2.5 Geology, Seismology, and Geotechnical Engineering

In Section 2.5, "Geology, Seismology, and Geotechnical Engineering," of the SSAR, SERI provided a detailed description of the geological, seismological, and geotechnical engineering properties of the ESP site. In this SER, Section 2.5.1, "Basic Data," describes basic geological and seismological data, especially the data published since 1986 for the area within a 200-mile radius of the ESP site, and presents updated seismic sources. Section 2.5.2, "Vibratory Ground Motion," evaluates the vibratory ground motion for the ESP site and analyzes the safe-shutdown earthquake (SSE) ground motion. Section 2.5.3, "Surface Faulting," describes the potential for surface faulting at or near the surface of the ESP site. Section 2.5.4, "Stability of Subsurface Materials and Foundations," presents the results of site geotechnical investigations and discusses the stability of subsurface materials and foundations. Section 2.5.5, "Stability of Slopes," defers the analyses for slope stability at the site and dam performance, respectively, to the COL stage. Finally, Section 2.5.6, "Embankments and Dams," briefly states that no embankments exist wi

Figure 2.5.4-12 (Updated final version of SSAR Figure 2.5.4-94)
 Damping Ratio Curves for Upland Complex Alluvium at
 4X Confining Stress

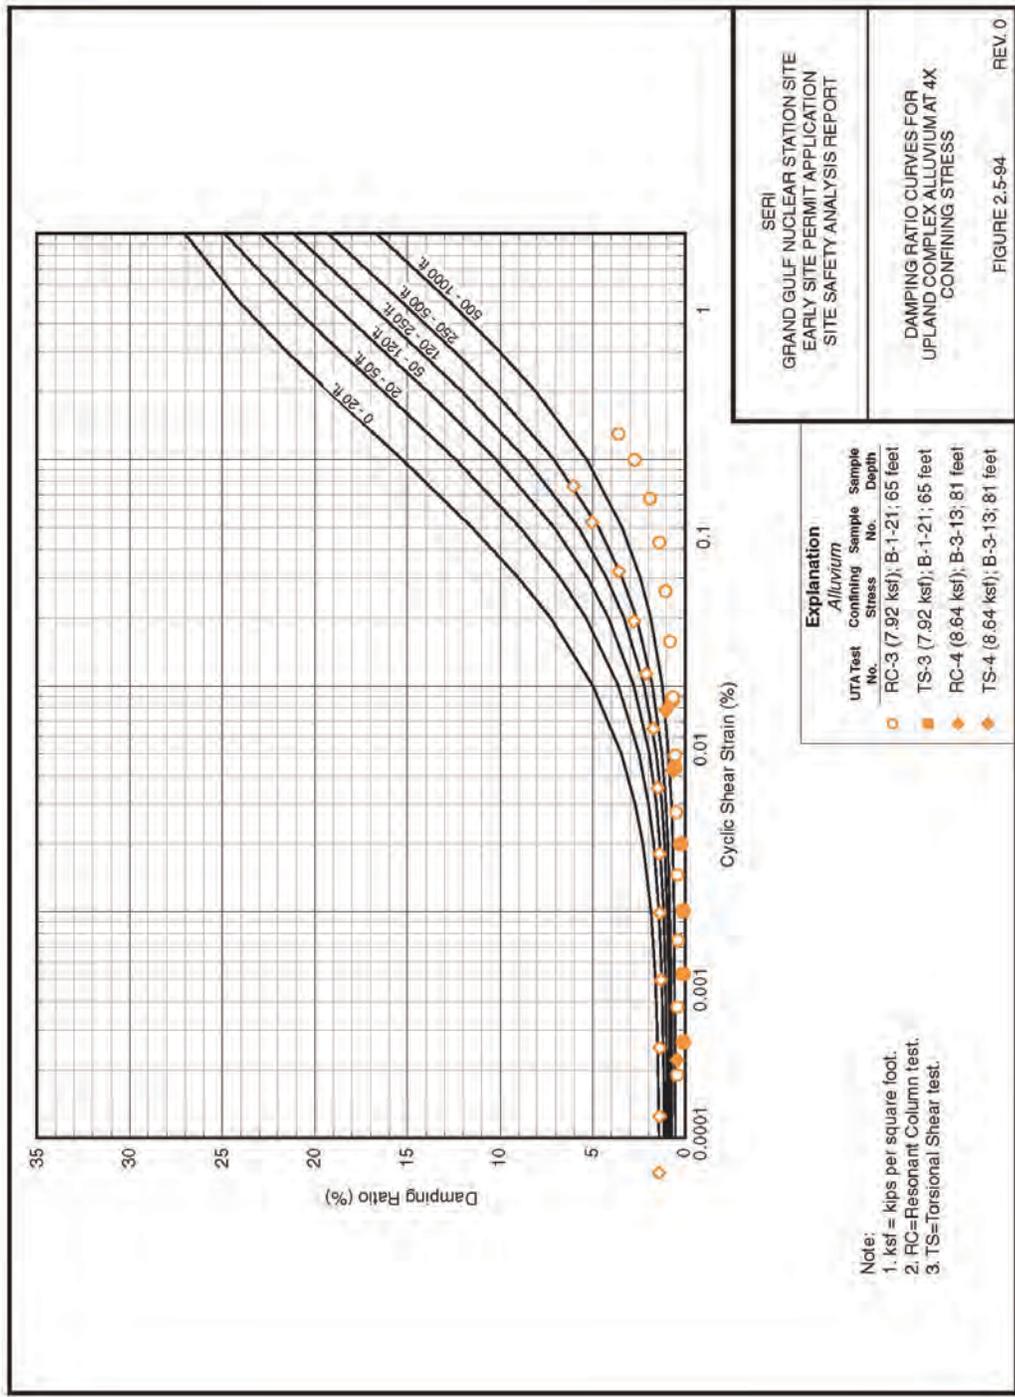
- Section 11.0 of ER-02 suggests that the laboratory results for specimens UTEXAS 1, 2, and 6 should be corrected to account for the effects of sample disturbance and/or underestimation of effective confining stress.

In RAI 2.5.4-7, the staff asked the applicant to provide its rationale for not incorporating these effects in the site response calculations and to evaluate the potential impact of these modifications on the computed surface UHRS. In its response, the applicant referred to its response to RAI 2.5.4-6 and stated that the analysis and selection of the appropriate EPRI-TR curves for shear modulus reduction and hysteretic damping fully account for the effects of possible disturbance to the test specimens resulting from stress release during sampling, as well as possible movements during testing. The applicant considered the effects of sample relaxation by examining the results from testing soils at both the estimated in situ confining stress and 4 times the estimated in situ confining stress. The applicant plotted these two data sets together on the EPRI-TR base curves as shown in Figures 2.5.4-5 through 2.5.4-12, which replicate SSAR Figures 2.5.4-87 to 2.5.4-94. The two data sets were weighted to select the most representative EPRI-TR curve.

In its response, the applicant further stated that the shear modulus reduction and damping curves adopted for use in the site response analysis represent the best fit to the dynamic soil test results that account for the effects of soil disturbance and overconsolidation. The applicant also considered the uncertainty and variability in these values in the site response modeling by developing randomizing curves about the selected base case EPRI-TR curves using an assumed lognormal distribution. The applicant further discussed the randomization process in its response to RAI 2.5.4-8 (for shear wave velocity input). The applicant considered that the EPRI-TR curves selected for the base case for site response analysis are appropriate for the site soil conditions and account for both sample disturbance and overconsolidation. Therefore, incorporation of these issues would not impact the computed surface UHRS.

**Figure 2.5.4-13 (Figure 2.5.4-4-1 of the RAI response)
Deep Profiles for Sensitivity Analyses**

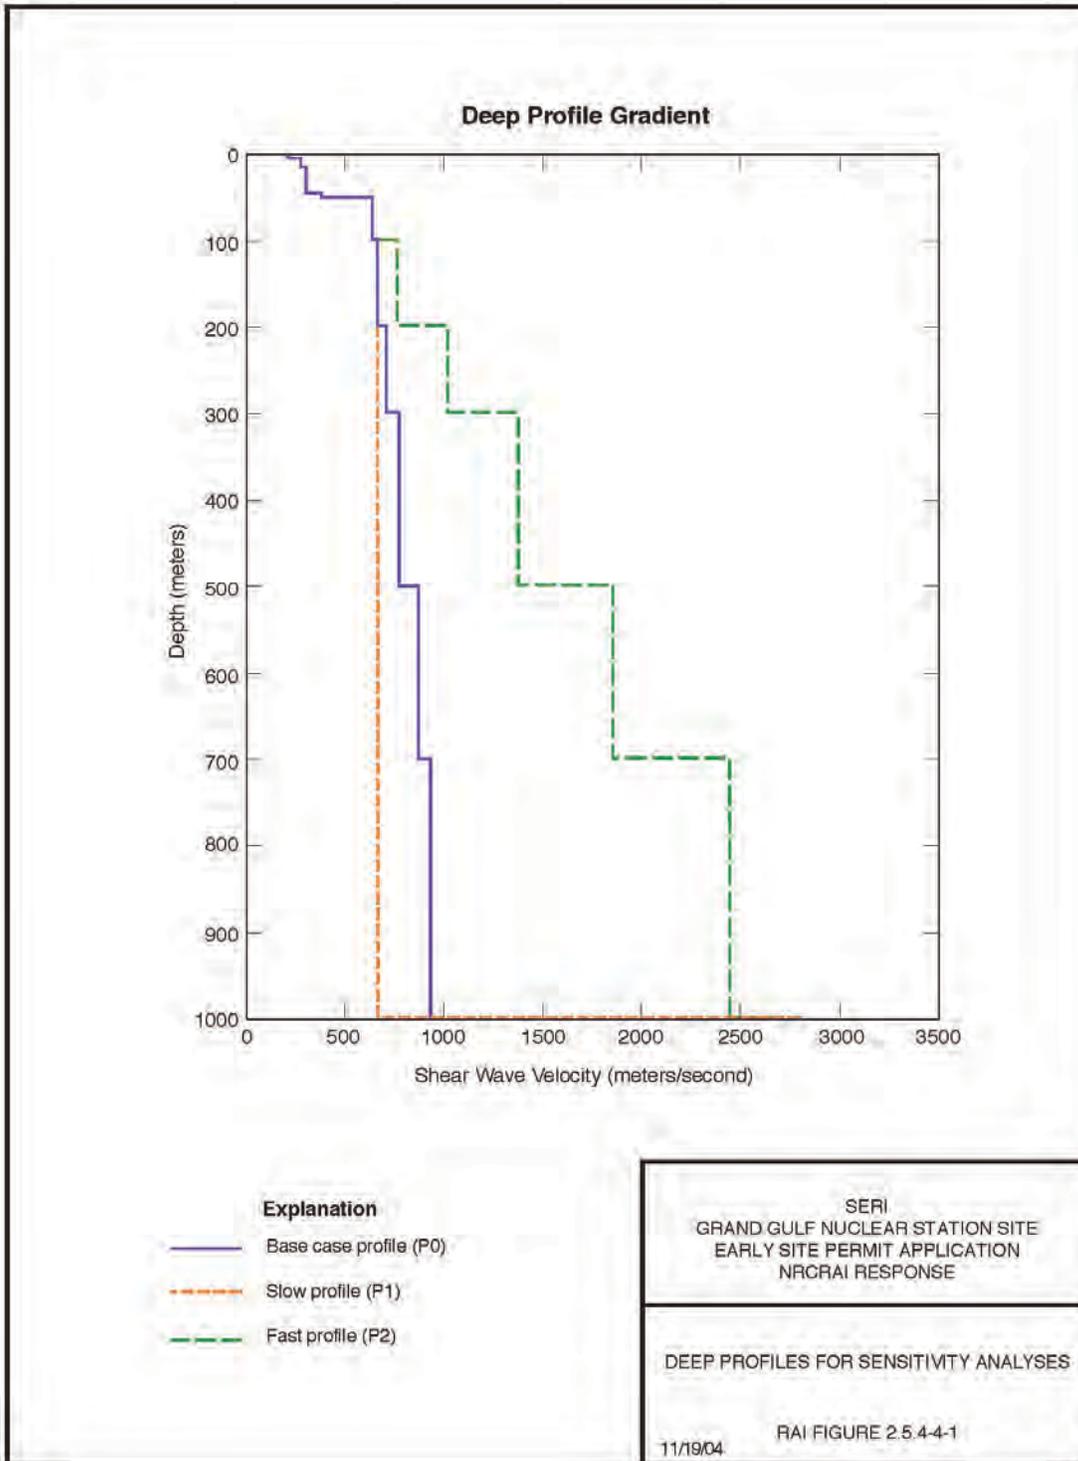
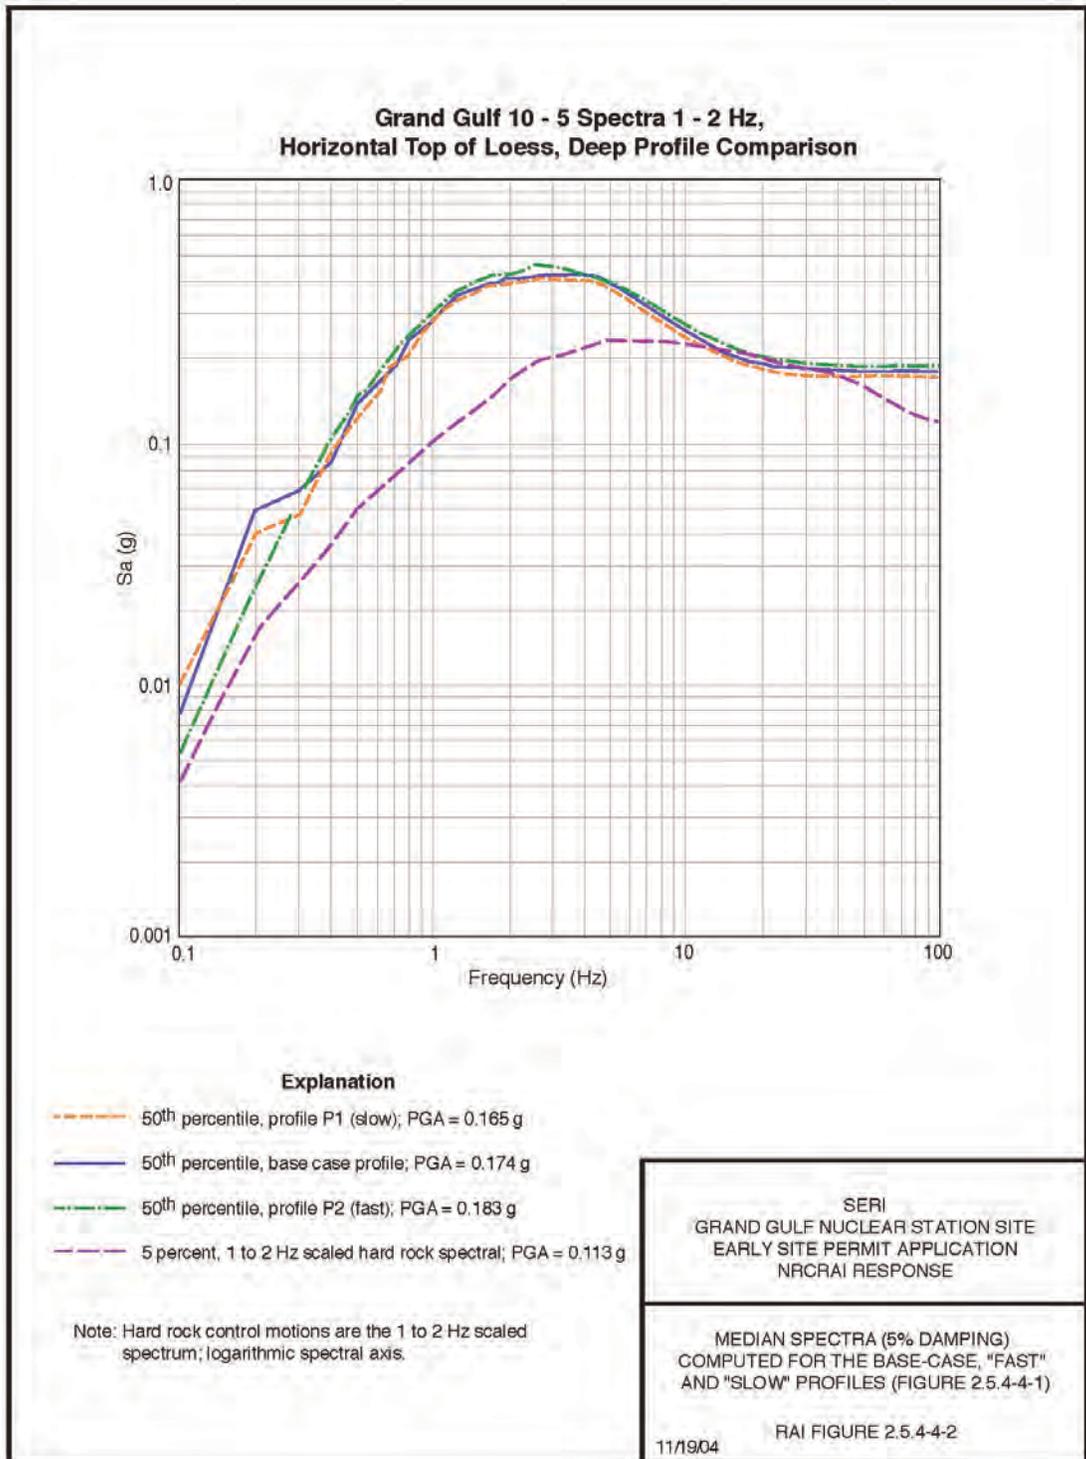
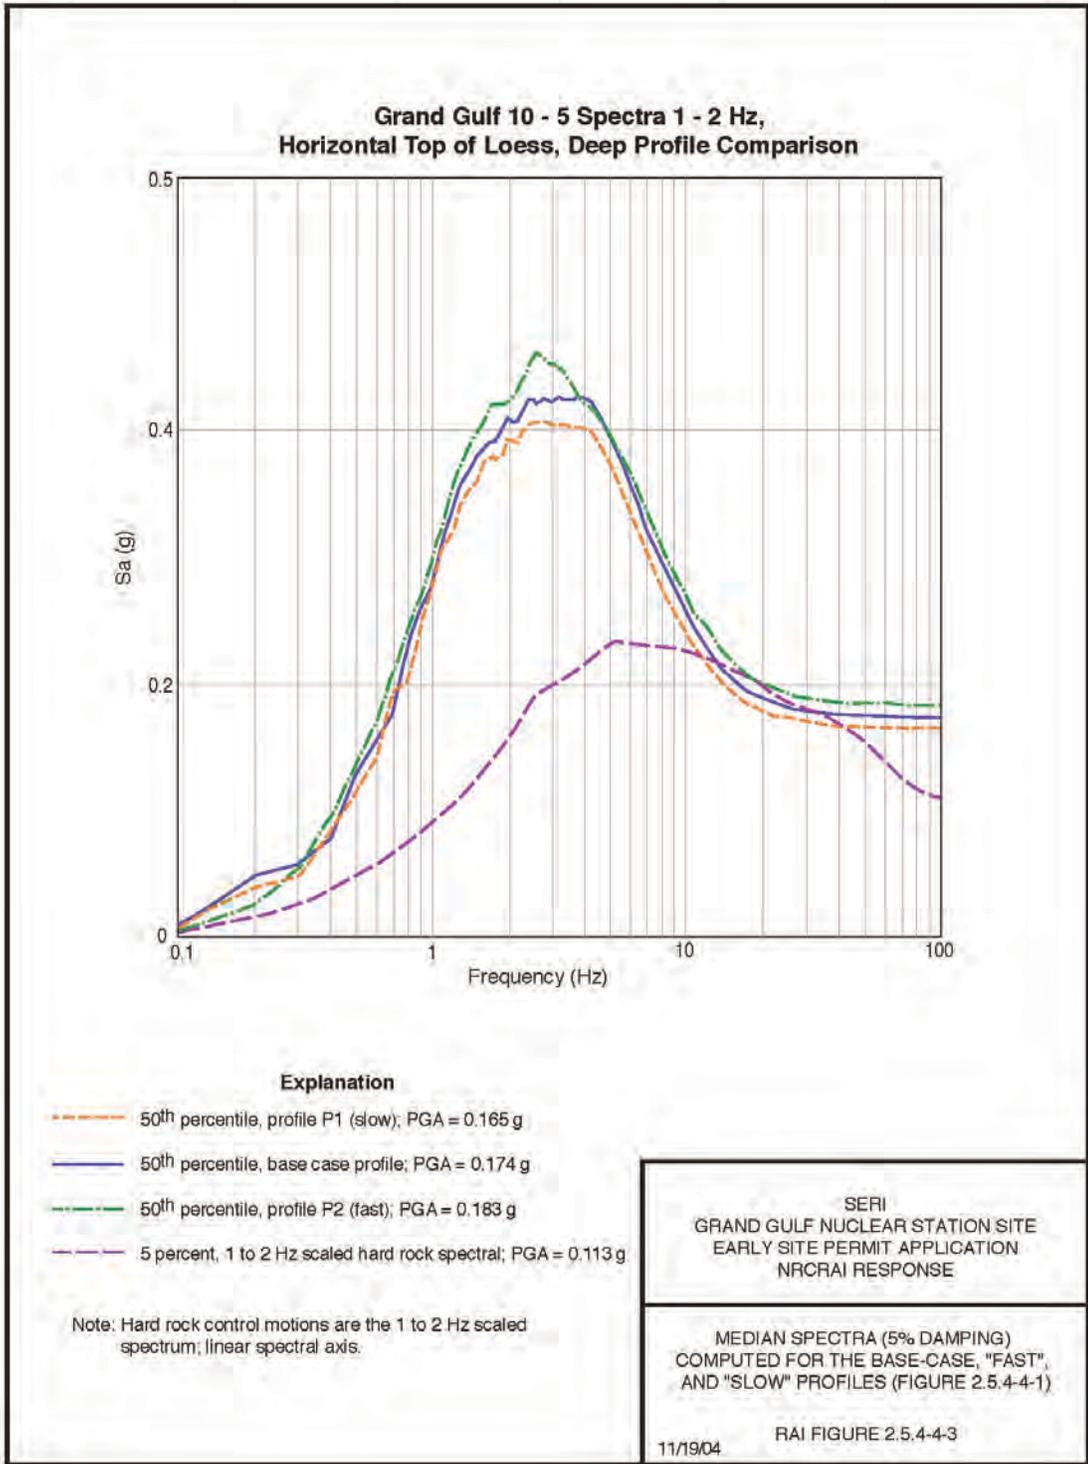
In seismic response analyses, shear and compression wave velocities, material densities, and strain-dependent modulus reduction and hysteretic damping data are necessary for the entire soil column extending to the depth considered in the site response evaluation. As indicated in Figure 2.5.2-4, the applicant assumed that the hard rock, with a shear wave velocity of 9186 fps, is located at a depth of 3281 feet and adopted a generic profile proposed for the Mississippi embayment region. This shear wave profile is relatively smooth, with a shear wave velocity varying from approximately 820 fps at the ground surface to a value of 9186 fps at a depth of 3281 feet. The applicant also replaced the upper 197 feet of the profile with a site-specific velocity profile generated by the geophysical program described previously. Therefore, of the entire 3281 feet of the profile, only the upper 197 feet are reasonably constrained. No site-specific information is available below this depth. However, it is a common practice for the sites where critical facilities are located to have one or more base case shear wave velocity models from site-specific data (e.g., well logs and deep borings) and then to generate soil UHRS using the probabilistic method of NUREG/CR-6728. In RAI 2.5.4-4, the

To compare the median motions computed for the three profiles, the applicant stated that it used the 1- to 2-Hz-scaled 10^{-5} APE spectrum as the control motions to excite the column at low as well as high frequency since it is quite similar to the UHRS and sufficiently broad band (i.e., large magnitude) compared to the UHRS. Figures 2.5.4-14 and 2.5.4-15 show the resulting soil median motions in both the logarithmic and linear spectral axes, respectively. As expected, little difference exists between the motions computed for the three profiles from 0.3 to 100 Hz. At peak acceleration, the fast and slow profiles show about a 5-percent increase and decrease, respectively, in motions, as compared to the base case profile. The motions reflecting the fast profile generally exceed those of the base case by about 5 percent. The largest exceedance is near a resonance at about 3 Hz, at which the fast profile motions exceed the base case motions by about 10 percent. Based on regional geology as well as experience with similar geology in deep basins, this fast profile is extremely unlikely and would receive very low weight in a hazard analysis. The applicant stated that these site response analyses illustrate the general insensitivity of the motions to the nature of velocity gradients likely to exist in the deep materials beneath the site.

**Figure 2.5.5-1 (RAI Figure 2.5.5.1-1)
 Schematic Section Showing Relationships
 Between Loess Bluff Slide and ESP Site**

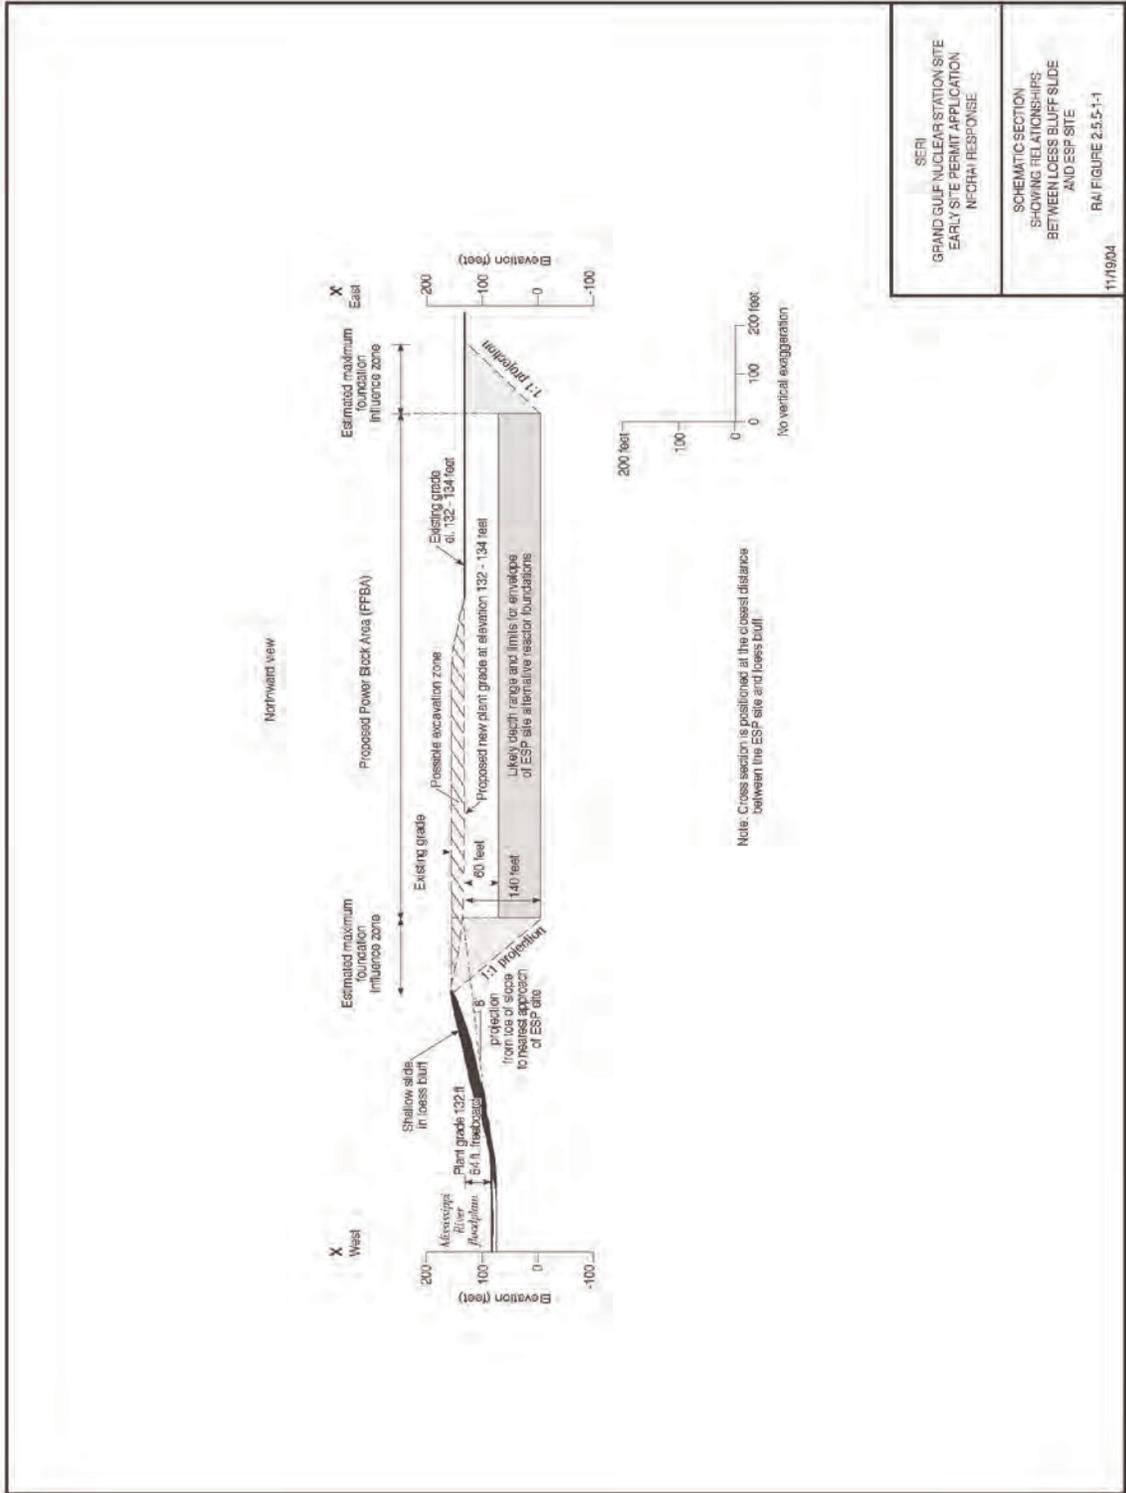
As stated in the SSAR, no plans exist to perform specific analyses to evaluate the stability of deep foundation excavations for the future facilities at the proposed ESP site until the COL phase. In addition, the applicant stated that it did not find any indications of unstable materials underlying the site that should cause unusual stability conditions for excavations and excavation support. In SSAR Section 2.5.5 and Sections 3.3 and 12.5.2 of ER-02, the applicant noted that a 60–70-foot escarpment that may be subjected to surficial slumps and potential creep of the loess soils bounds the west side of the proposed ESP site. The applicant further stated that, since future safety-related facilities would be founded on Upland Alluvium or Old Alluvium encountered below the loess, future movements of the slope should not have any significant impact on these foundations. However, if such facilities are founded close to the scarp, such slump or creep effects could have an impact on lateral loads applied to such deeply founded facilities. In RAI 2.5.5-1, the staff asked the applicant if it had performed any evaluation to indicate the expected behavior of the loess escarpment or the extent to which such movements could occur. In addition, the staff also asked the applicant if the ESP site should have some exclusionary zones along the west-side boundary that would not be susceptible to such potential future slump. In its response, the applicant stated that SSAR Figure 2.5-69 shows the spatial relationships among the PPBA and the loess bluff and the postulated shallow slump in the bluff near the west boundary of the ESP site. The applicant evaluated the potential hazard to the site from slope failure and creep in the loess bluff by examining geologic cross-sections, evaluating embedment depths and positioning of ESP structure foundations, and qualitatively assessing the bluff slope stability in relation to the relative strength of subsurface materials. The applicant further stated that it developed a simplified cross-section to show the geometric relationships between the loess bluff and the site. In this schematic cross-section, the PPBA is set back over 100 feet from the closest approach of the bluff and top of the postulated slump. The maximum foundation influence zone envelope extends to just within the headscarp of the slump area. However, the likely depth range for the prospective reactor foundations required to satisfy minimum embedment and shear wave velocity criteria places the foundation level about 10–80 feet below the elevation of the toe of the bluff slope. The applicant also stated that it is unlikely to develop a failure plane that extends from the toe of the bluff or headscarp of the postulated slump back to the PPBA. A failure plane would have a very gentle inclination of about 8 degrees and would need to intercept the perimeter of the PPBA at least 5–10 feet below plant grade. The applicant believed that such a low-angle failure plane is very unlikely based on an estimated in situ effective friction angle of 33–34 degrees measured by triaxial UC

testing of loess samples. Therefore, the applicant concluded that no kinematically feasible bluff failures could extend back to, or negatively impact, the stability and lateral confinement of prospective reactor foundations within the PPBA. Based on the qualitative stability assessment, the hazard to the ESP site from possible future movements in the loess bluff is very low to none and does not require additional analysis at this ESP stage. The applicant stated that an exclusionary zone between the top of the bluff and the ESP PPBA, therefore, is not necessary.
